Work Order ID 156615

Item Name: AS350/AS355 Quick Release Heli-Utility-Basket™ Long, Lightweight Lid

DART SERVICE INSTRUCTION

**TO AMEND INSTALLATION INSTRUCTIONS D350-607-3 Rev.D,
INSTALLATION INSTRUCTIONS D350-607-4 Rev. C AND
INSTRUCTIONS FOR CONTINUED AIRWORTHINESS ICA-D350-607 REV. 6**

FIGURE 1: INSTALLATION OF D4775-041 FWD STRUT

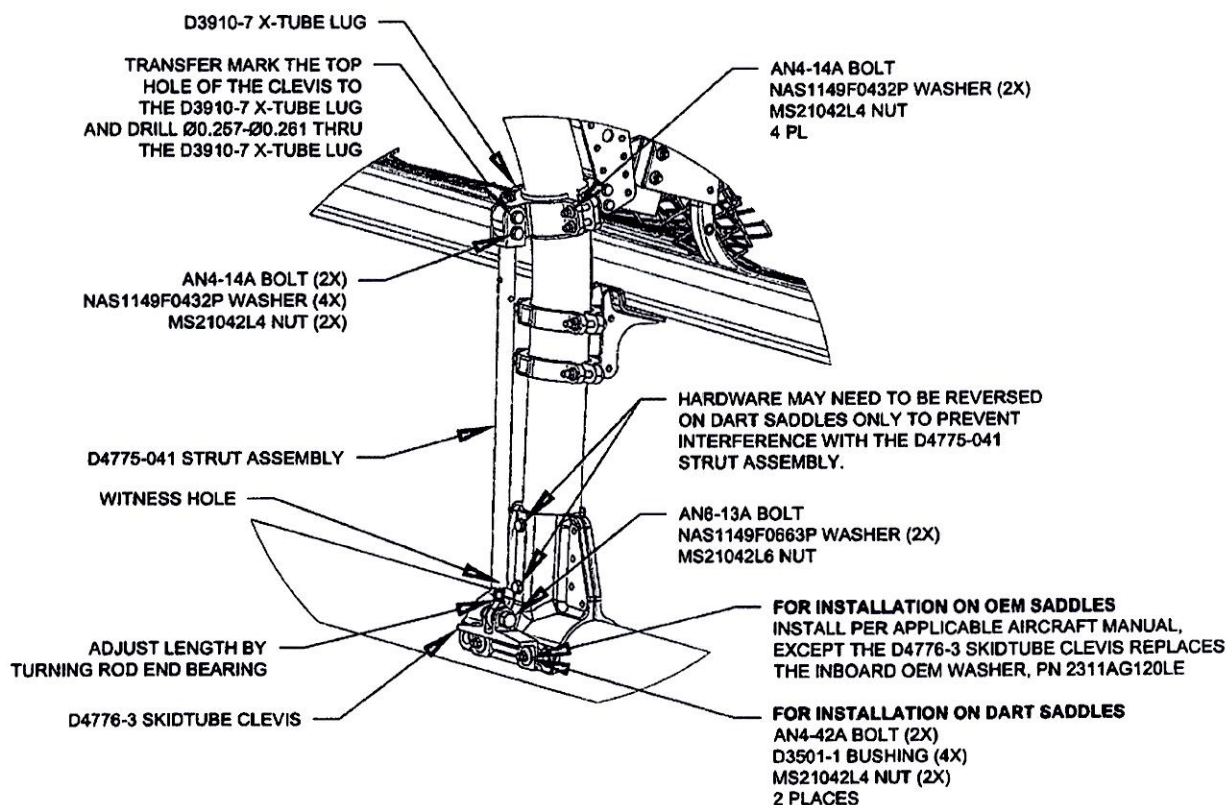
Modify the quantities for D3910-5 and add D3910-7 as follows:

- 3.1 Substitute the Forward Lower D3910-5 X-Tube Lug with the D3910-7 X-Tube Lug as shown in Figure 1.
- 3.2 Install the forward D4775-041 Strut Assembly. Transfer mark from the upper hole on the clevis of the D4775-041 Strut Assembly to the D3910-7 X-tube Lug and drill thru the lug $\varnothing 0.257$ - $\varnothing 0.261$ as shown in Figure 1. Touch up chemical conversion coating per MIL-DTL-5541. Check the witness holes located at the bottom end of the D4775-041 Strut Assemblies to ensure that the thread from the rod end extends past the witness hole.
Torque MS21042L4/-4 nuts to 50-70 in-lbs (5.7-7.9 N-m). Torque MS21042L6/-6 nuts to 160-190 in-lbs (18.1-21.5 N-m).
- 3.3 Complete the installation in accordance with Installation Instructions D350-607-3 Rev. D or D350-607-4 Rev. C.

Install the D350-607-501 Conversion Kit, D350-607-511 Quick Release Mounting Kit or D350-607-431 Strut retrofit kit per Installation Instructions D350-607-3 Rev. D or D350-607-4 Rev. C. While installing the Forward Strut perform the following:
